00-R-421B
AMENDMENT-2
August 1, 1980
SUPERSEDING
INT. AMENDMENT-1 (NAVY-SH)
June 25, 1979

FEDERAL SPECIFICATION

RIVETER, PNEUMATIC, JAM AND HAMMER; AND HOLDER-ON, PORTABLE

This amendment which forms a part of 00-R-421B, dated June 9, 1976, was approved by the Commissioner, Federal Supply Service, General Services Administration, for the use of all Federal agencies.

Figure 3. Type II, aircraft riveting hammers."

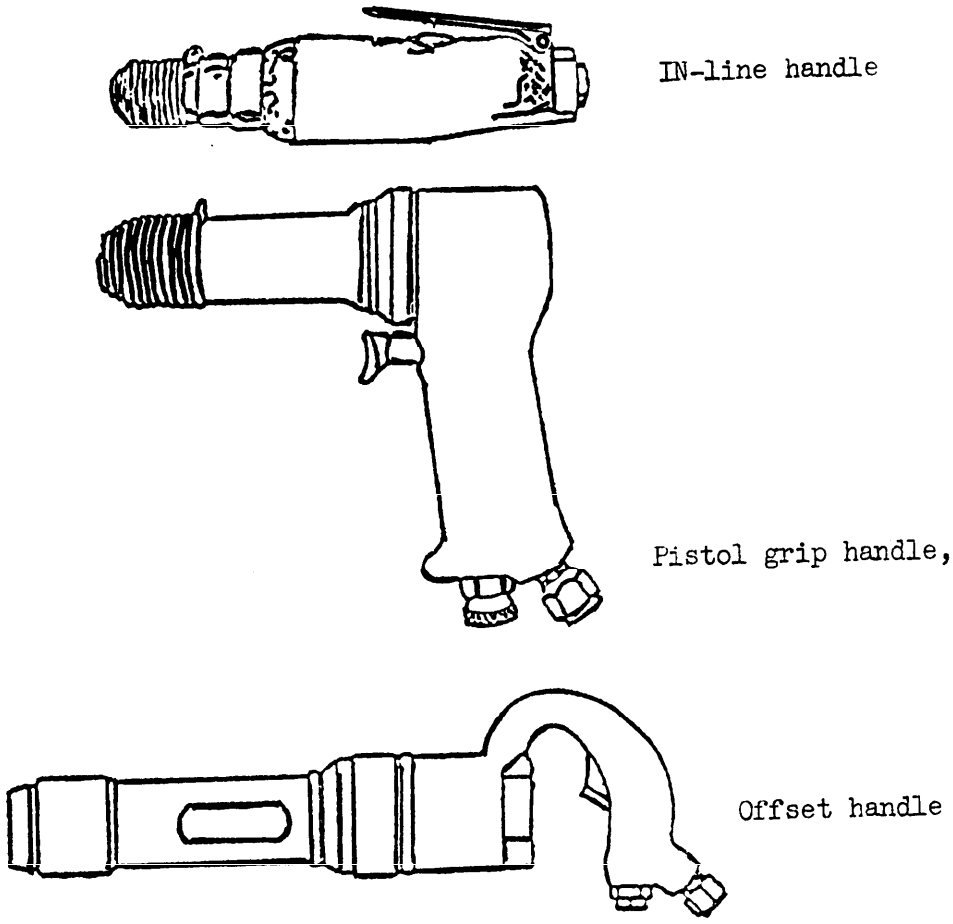
Figure 3: Delete and substitute:
